UNITED STATES PATENT AND TRADEMARK OFFICE

APPLICATION NO.	FILING DATE	FIRST NAMED INVENTOR	ATTORNEY DOCKET NO.	CONFIRMATION NO.
10/599,363	07/23/2008	Hedi Slimane	28944/50047	7383

Office Action Summary	Application No. 10/599,363	Applicant(s) SLIMANE, HEDI	
	Examiner DEVIN BARNETT	Art Unit 3637

DETAILED ACTION

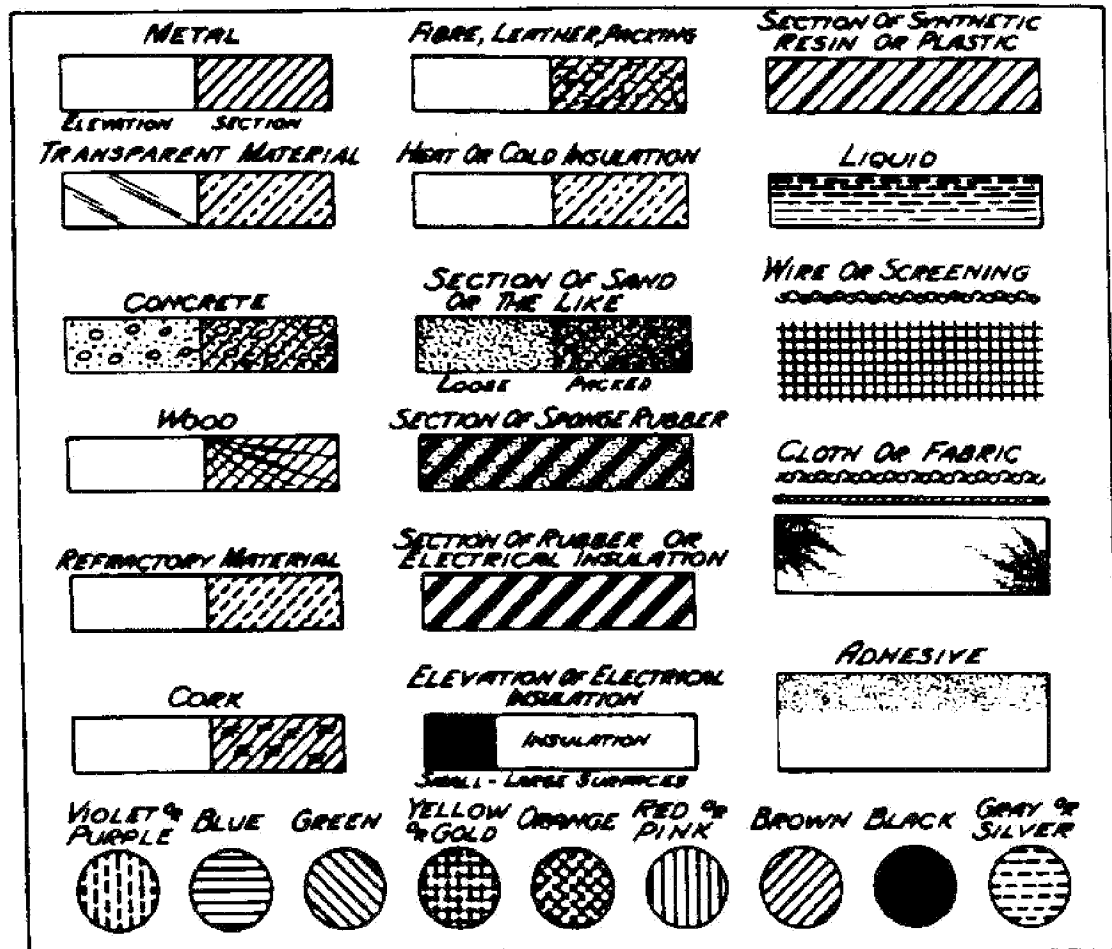
The drawings are objected to under 37 CFR 1.83(a). The drawings must show every feature of the invention specified in the claims. Therefore, the transparent plate resided in claim 6 must be shown with the correct hatch marks (a chart is provided below 37 CFR 1.84(n)) or the feature(s) canceled from the claim(s). No new matter should be entered.

Corrected drawing sheets in compliance with 37 CFR 1.121(d) are required in reply to the Office action to avoid abandonment of the application. Any amended replacement drawing sheet should include all of the figures appearing on the immediate prior version of the sheet, even if only one figure is being amended. The figure or figure number of an amended drawing should not be labeled as “amended.” If a drawing figure is to be canceled, the appropriate figure must be removed from the replacement sheet, and where necessary, the remaining figures must be renumbered and appropriate changes made to the brief description of the several views of the drawings for consistency. Additional replacement sheets may be necessary to show the renumbering of the remaining figures. Each drawing sheet submitted after the filing date of an application must be labeled in the top margin as either “Replacement Sheet” or “New Sheet” pursuant to 37 CFR 1.121(d). If the changes are not accepted by the examiner, the applicant will be notified and informed of any required corrective action in the next Office action. The objection to the drawings will not be held in abeyance.

Claim 1-5, and 7-8 are rejected under 35 U.S.C. 103(a) as being unpatentable over Richman D250,441 in view of Einbinder 2,109,586.

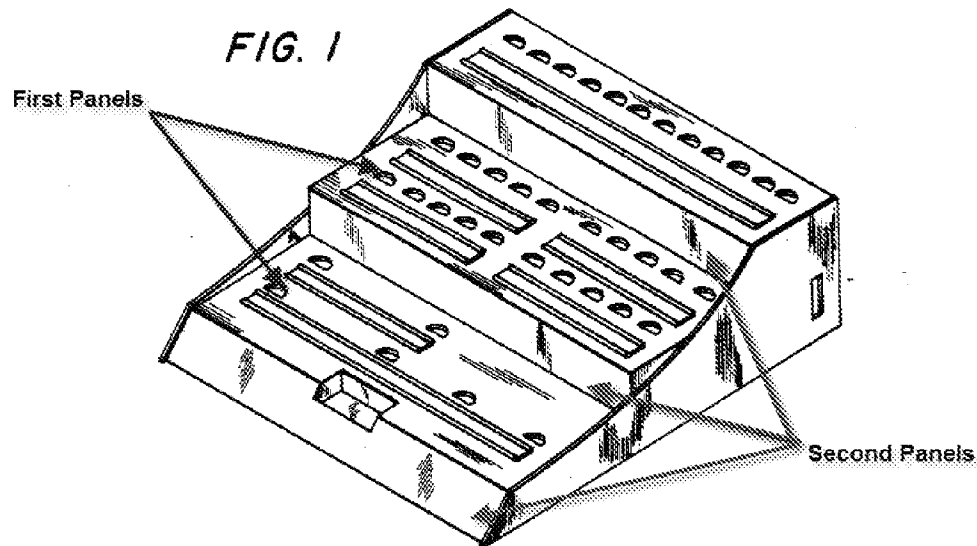
Regarding claim 1, Richman discloses a vertical display stand for articles such as cosmetic products, comprising: a vertical board that has a rear face and a front face, said front face formed at least partially by a plurality of first panels (annotated Fig 1 below) and a plurality of second panels (annotated Fig 1 below); the first and second panels being produced as a single piece together with the board; wherein said first and second panels are superposed vertically in alternance (as shown below); wherein the first panels are adapted to accommodate said articles.

Richman does not explicitly teach a display stand wherein the first panels are non transparent and the second panels are inclined relative to the first panels; wherein the first and the second panels define reliefs substantially in the form of crests, and at least one of the second panels arranged opposite one of the first panels has a reflective surface and is facing slantwise forward and downward such that a person facing the board can observe only a top portion of said articles, either directly, or indirectly by reflection in the second panel placed opposite said first panel.

It would have been obvious to one having ordinary skill in the art at the time the invention was made to fabricate the first panels from a non transparent material such as metal, since it has been held to be within the general skill of a worker in the art to select a known material on the basis of its suitability for the intended use as a matter of obvious design choice.

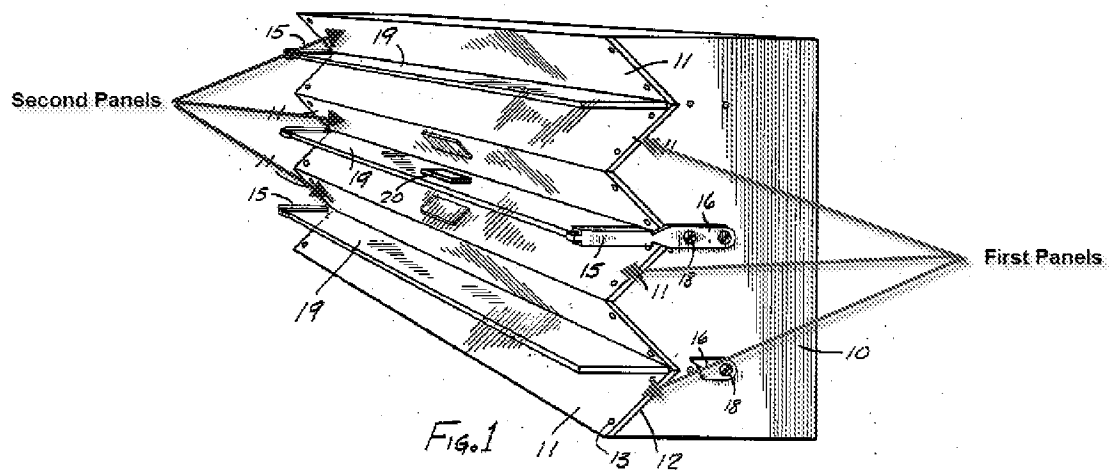
Einbinder discloses a display stand wherein the second panels (annotated Fig 1 below) are inclined relative to the first panels (annotated Fig 1 below); wherein the first and the second panels are superposed vertically in alternance thereby defining a relief substantially in the form of a crest (as shown in Fig 1), and at least one of the second panels arranged opposite one of the first panels has a reflective surface and is facing slantwise forward and downward.

It would have been obvious to one having ordinary skill in the art at the time the invention was made to modify the first and the second panels disclosed in Richman to be inclined as taught by Einbinder, because such a modification would have involved a mere change in the shape of a component. A change in size and shape is generally recognized as being within the level of ordinary skill in the art. Further, it would be obvious to
